Re: Concept Development Application - DA/812/2021 (PPSSCC-285)
33-43 Marion Street, Parramatta
Determination Meeting – 19 May 2022

Response to Issues – Concept Development Application – DA/812/2021
33-43 Marion Street, Parramatta

6 EXISTING 1400

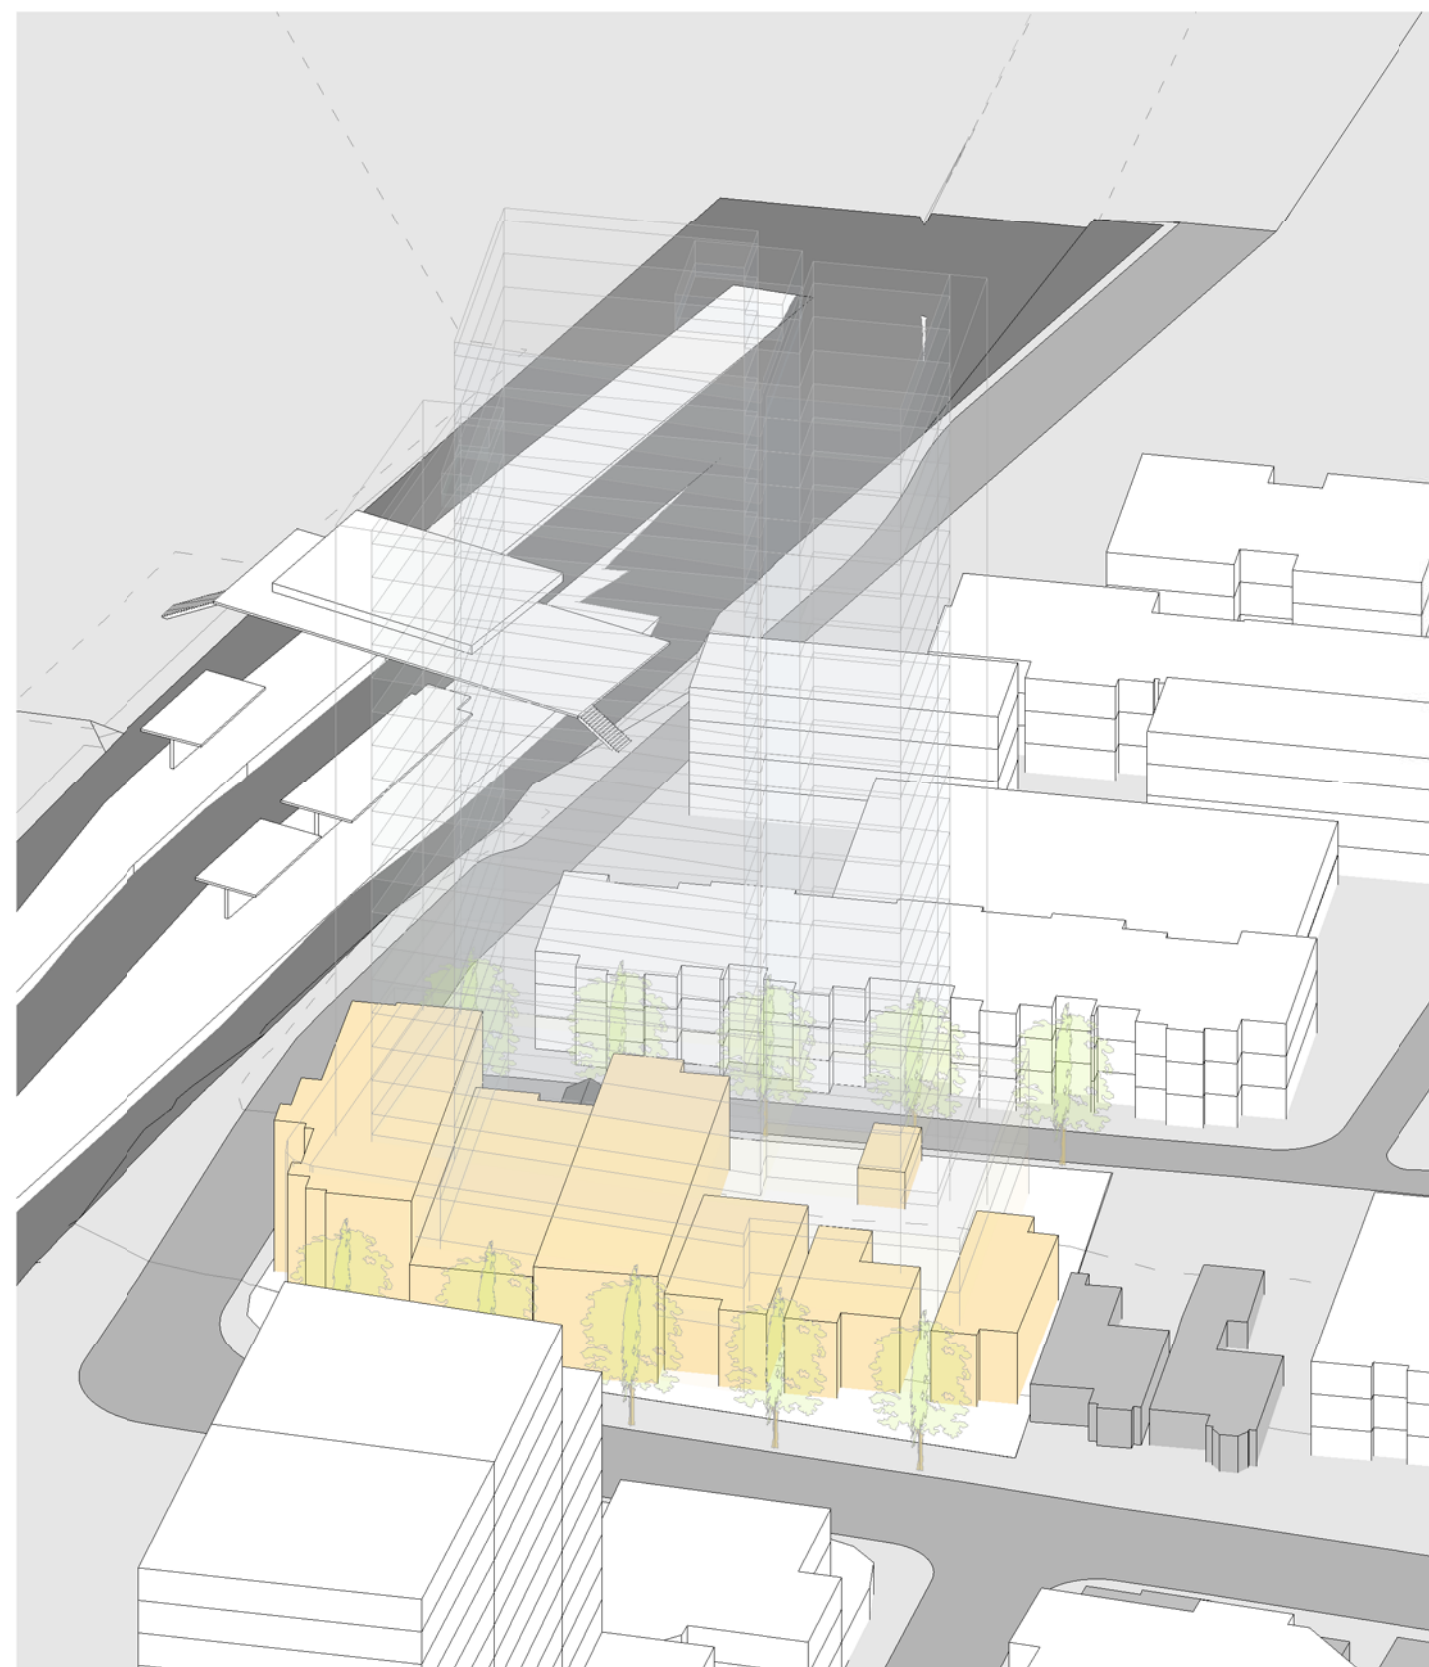
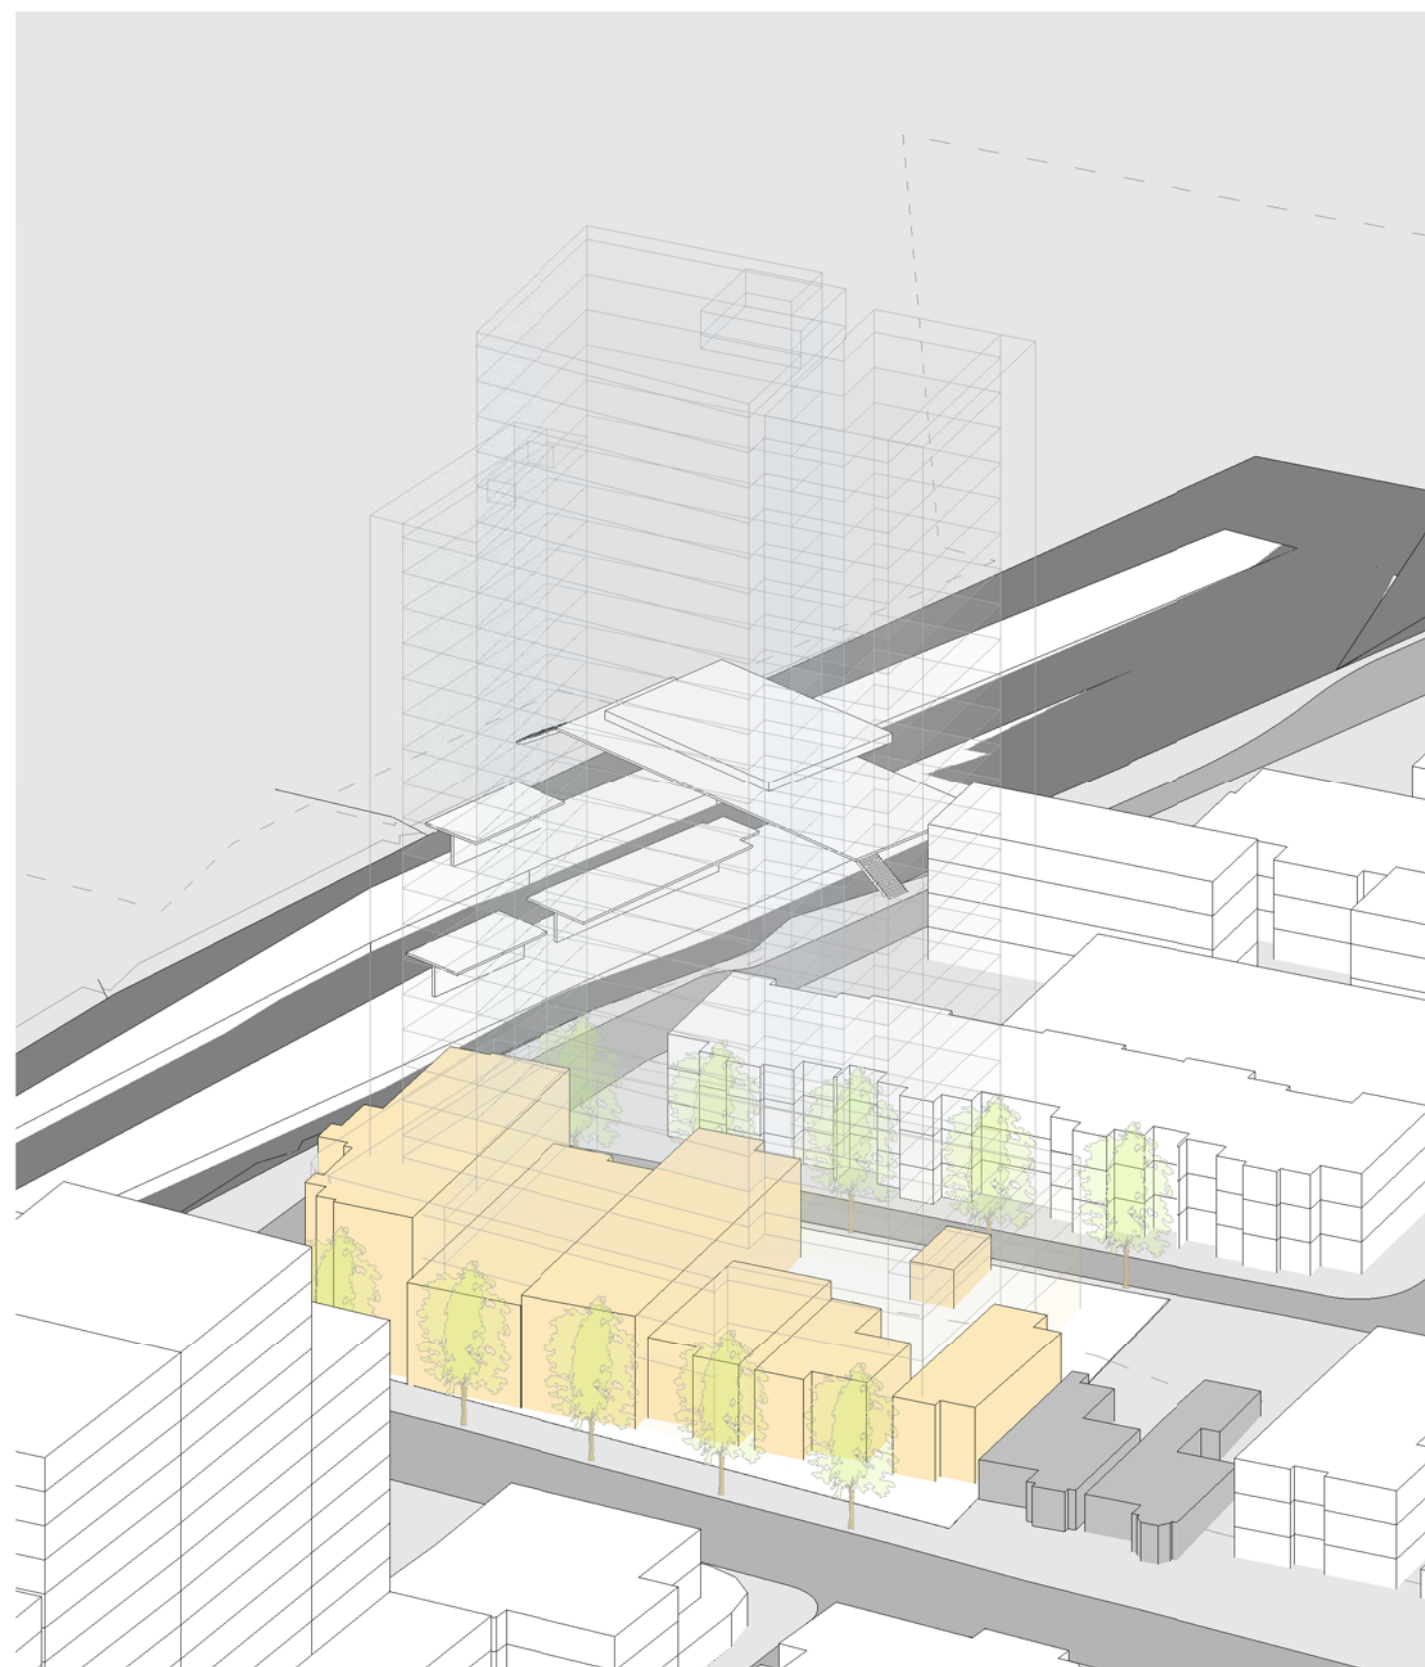
A solar access study has been prepared to assess in detail the potential impact to surrounding residential flat buildings, including 27 Station Street West and 69-71 High Street, Harris Park should the western boundary setback be reduced from 12m to 9m as proposed by the Concept Development Application.

The proposal is capable of achieving solar access to living areas and private open spaces to 70% of apartments at mid-winter and less than 15% of apartments with no solar access at mid-winter. No further change is required.

DRAWING
GROUND FLOOR LANDSCAPE PLAN

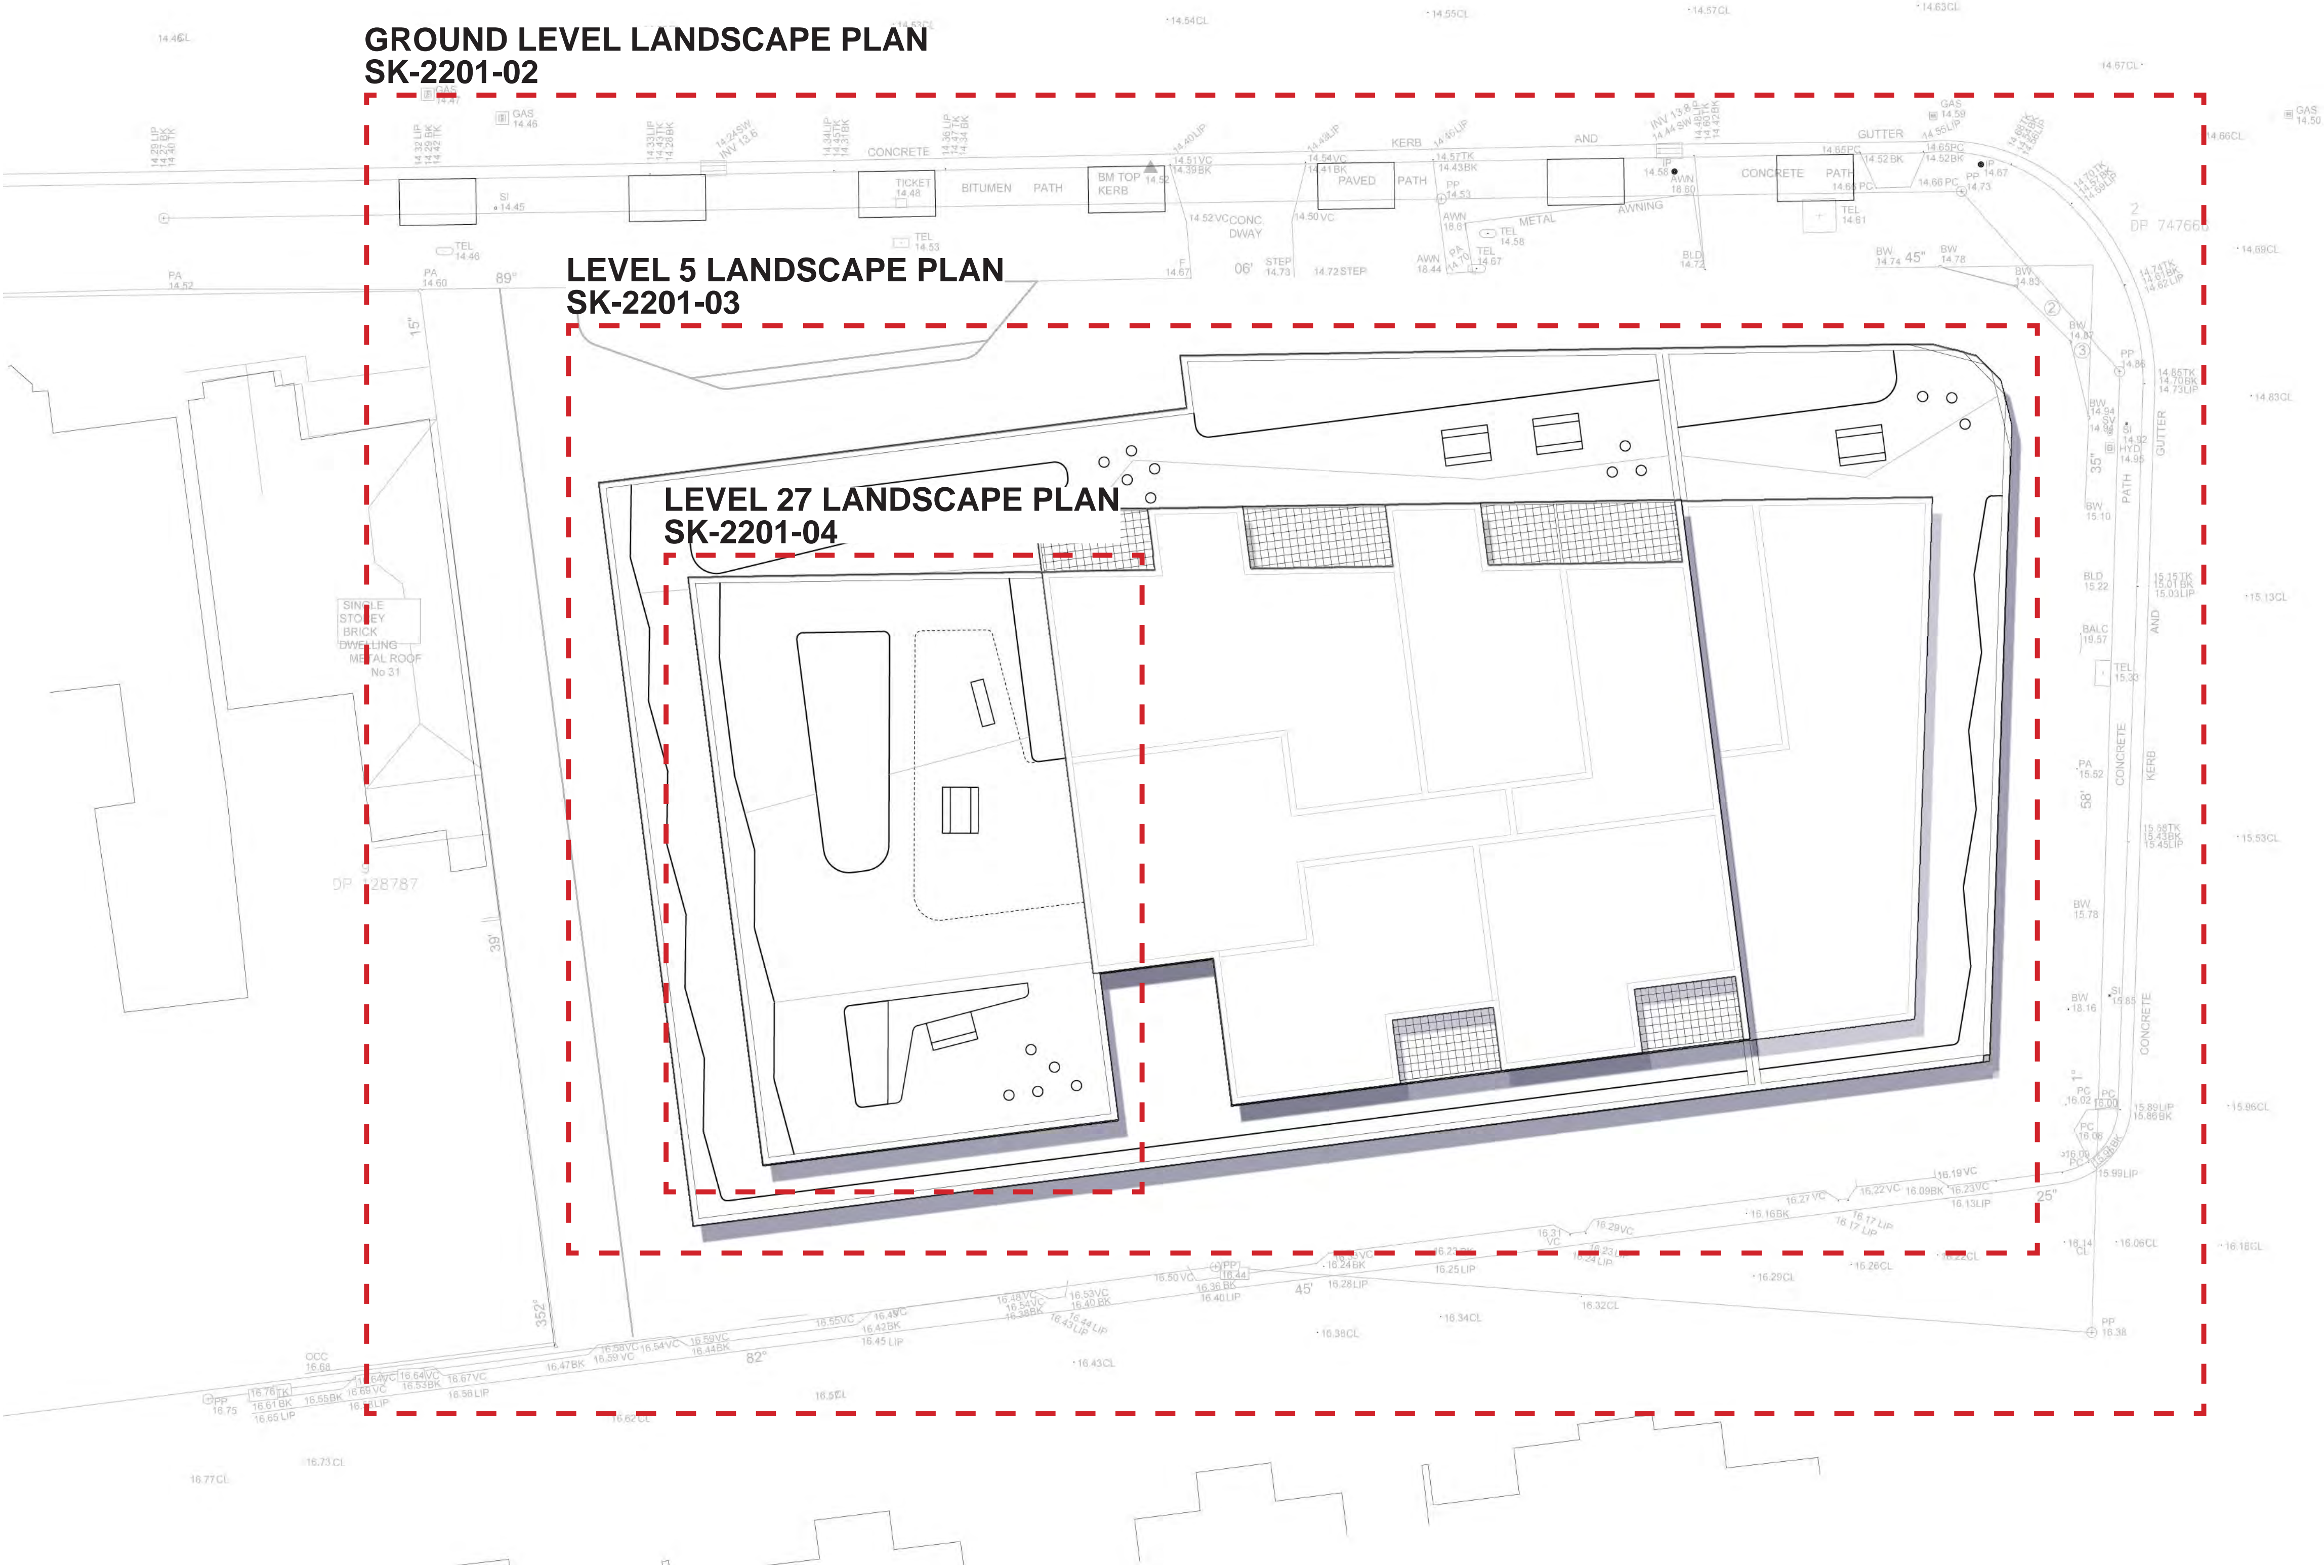
No deep soil or large tree planting proposed on site. No details of on-structure planting. As such, the proposal does not demonstrate that the future detailed DA could satisfy the criteria of excellence in landscape design.

No true deep soil proposed. Western boundary through site link would be ideal location, allowing tree planting to potentially improve heritage interface and ameliorate wind conditions in lane.

In summary, the landscape design has accommodated a minimum soil volume of 15m³ for small tress, with understorey planting to 2 metres tall and small tree to 8 metres tall along the through site link, which is of a

9. Through Site Link tree planting with layered understorey planting. Provide screening to neighbouring property. Understorey planting to 2m tall and small tree to 8m tall.
